#### **CONSTRUCTION SUMMARY**

#### **Kingsmen (Thames) Inc. / Havelock Corners (Kingsmen)**

Lot/Unit: 70 Phase/Building: 4A Model/Floor Plan: Spencer (4204) Elev C 4 Bed - 4+1 Bath

## Sketch #3

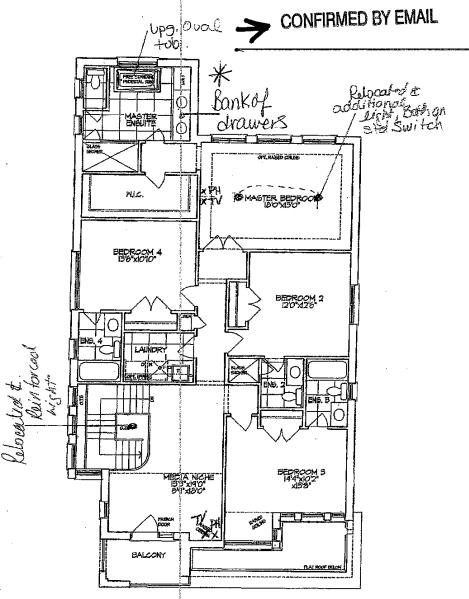
Inv. <b>4601</b>	1 - To supply & install a WALL CABINET WITH SHELF FOR MICROWAVE - FINISHED INTERIOR - OPENING 24INCHESW X 13 3 - 4INCHESH X 17INCHESD - CLASSIC SERIES see sketch # 3	
Line 58764	Note: Electrical outlet is sold sep.	
15Apr20 / 16Apr20
